Reviewed for **2018 Code Compliance Yavapai County Building Safety**

NEW RESIDENCE

165 Courthouse Butte Sedona, AZ 86351

SITE PLAN & COVER PAGE

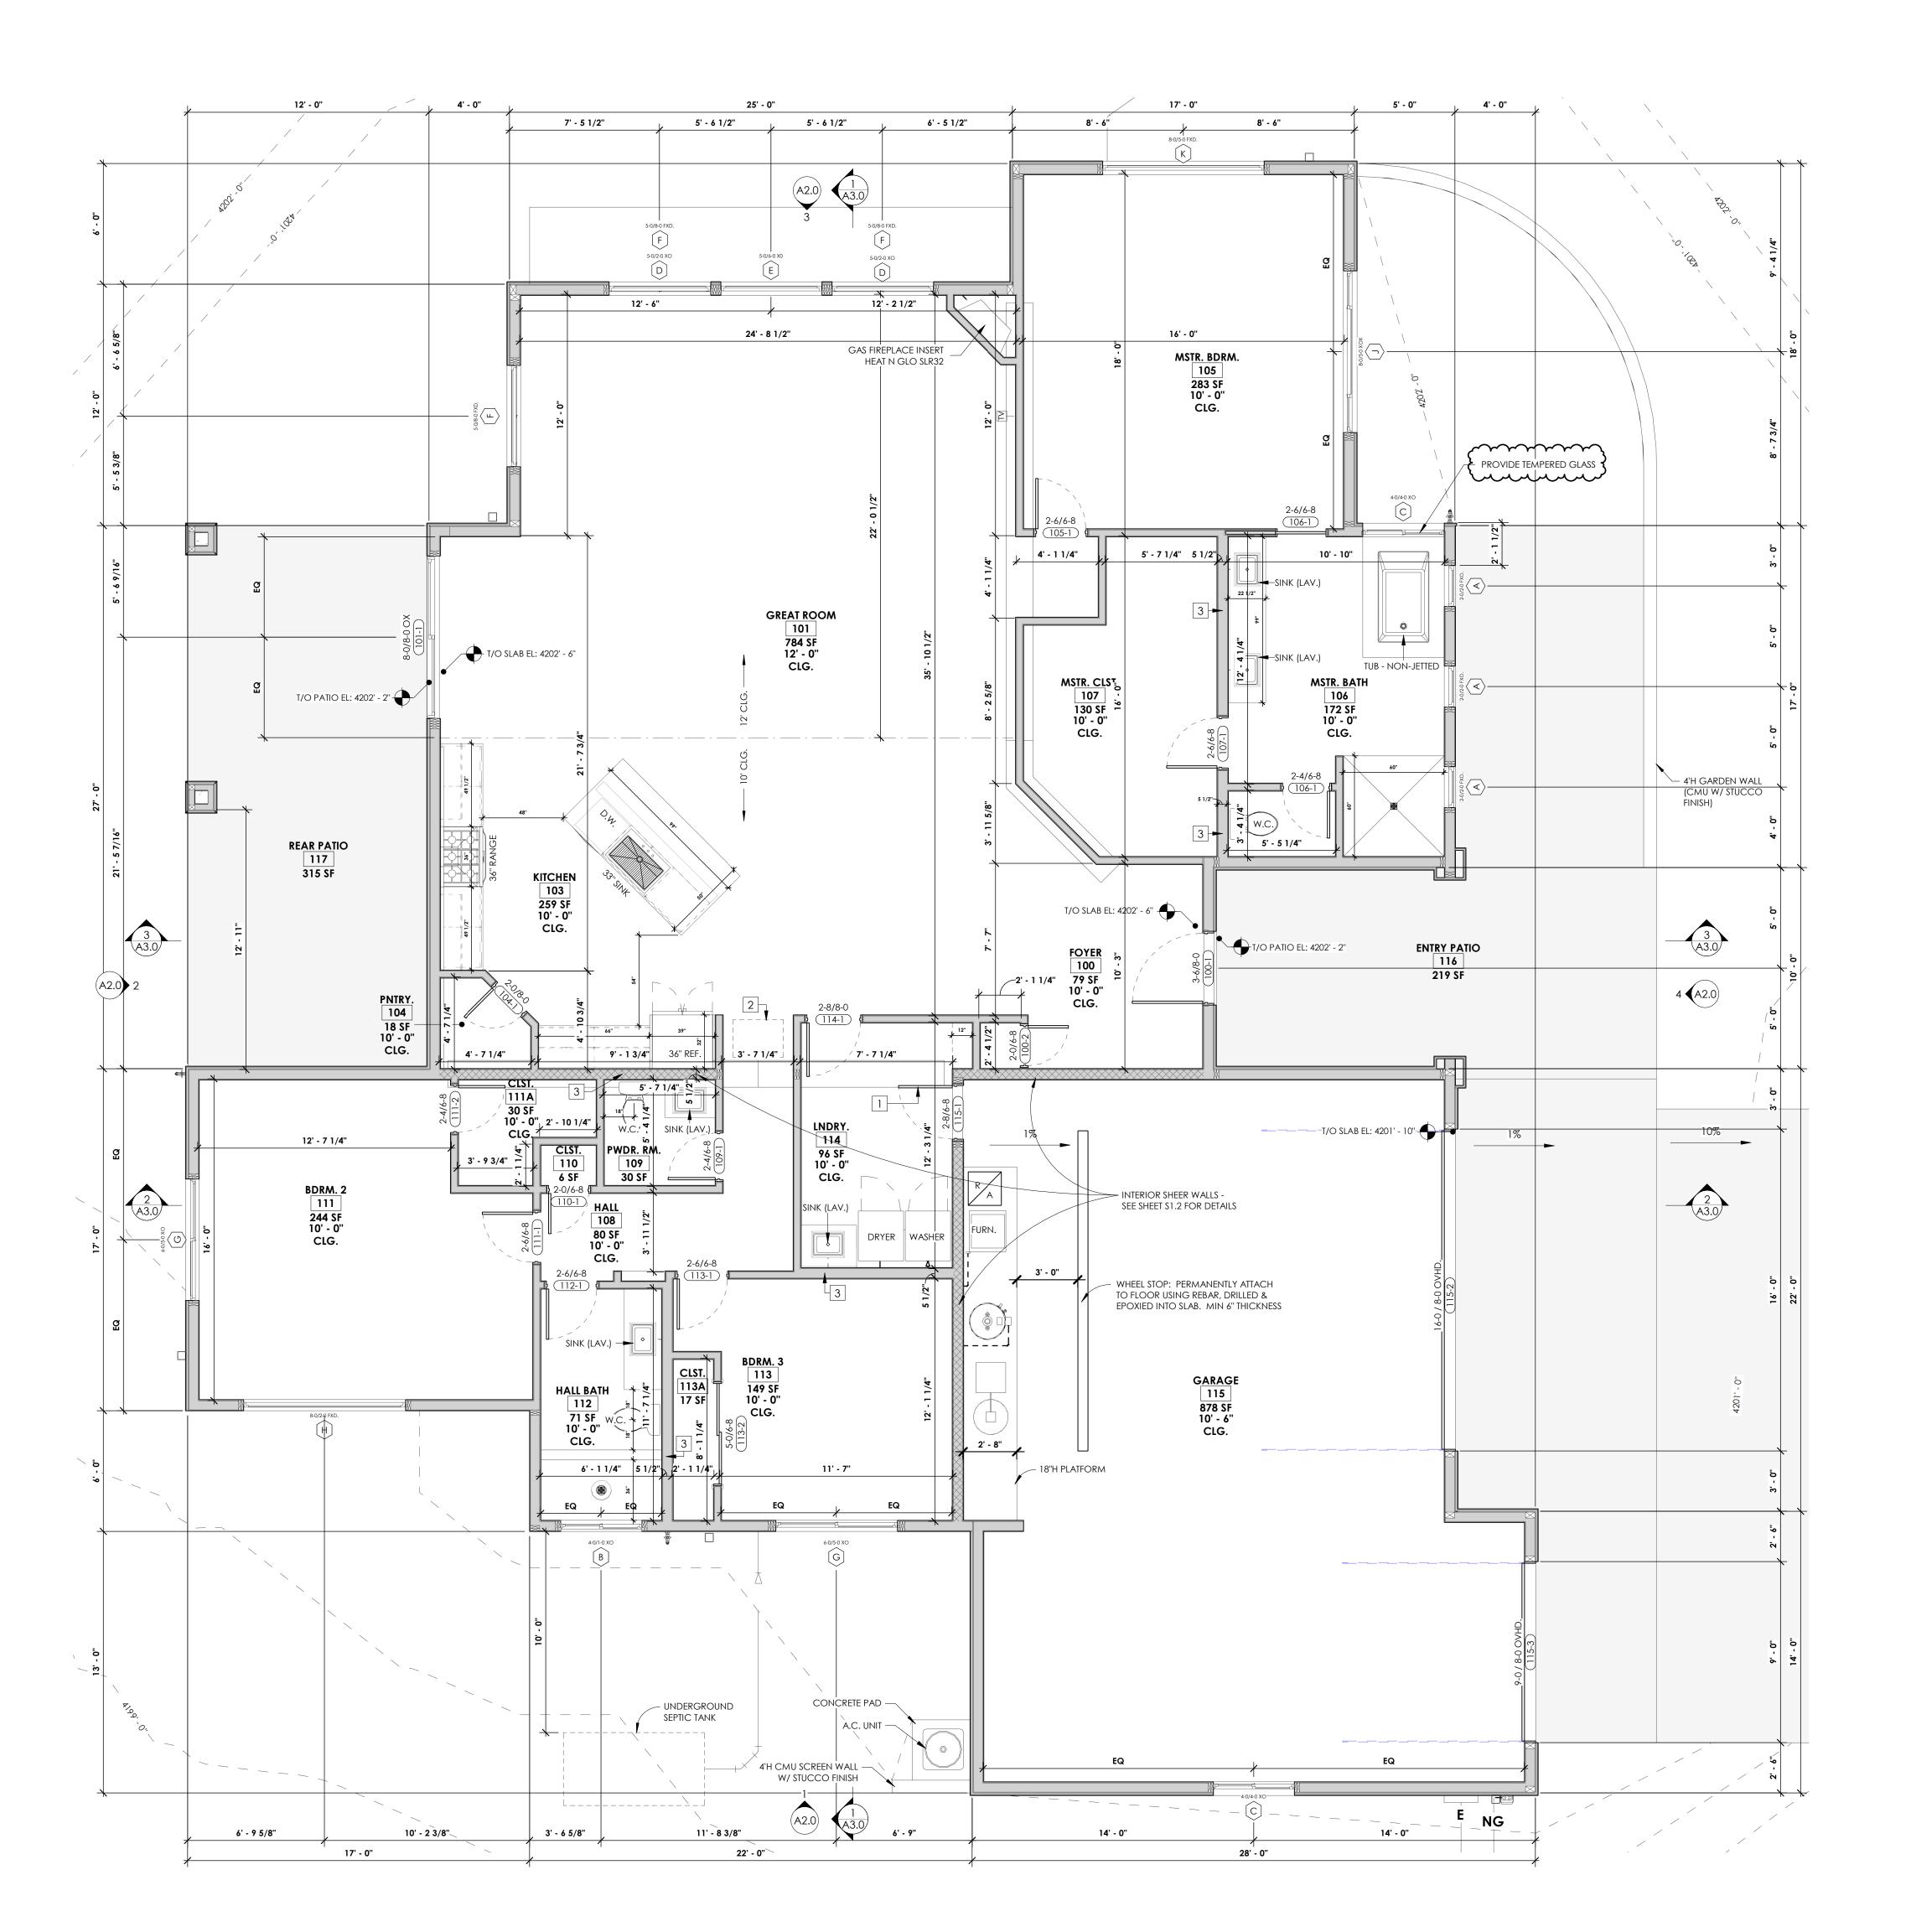
Interconnected smoke detectors

are required for this project per

2018 IRC R314.3.1. Each sleeping

room, outside each sleeping

room and on each floor level.

Effective April 20, 2006,

Fully shielded fixtures are

required for all exterior lamps

Per Article 210.12 of the

2017 NEC

Arc fault circuit interupters

are required

Per 2018 IRCR309.1, R309.2, and IBC 406.3.3: Garage/ carport surfaces used for parking of vehicles shall be sloped to drain liquids to the main vehicle entry doorway or an approved drain

2018 IRC R311.3 There shall be a floor or landing on each side of the exterior door. The width of the landing shall not be less than the door served with a minimum distance of 36" measured in the direction traveled

Provide at least one window or exterior door approved for emergency escape or rescue for every room used for sleeping purposes. 2018 IRC R310.1

RAIN GUTTERS & DOWNSPOUTS ARE REQUIRED

Positive drainage away from the structure is required. Refer to the geotechnical report for an additional requirements
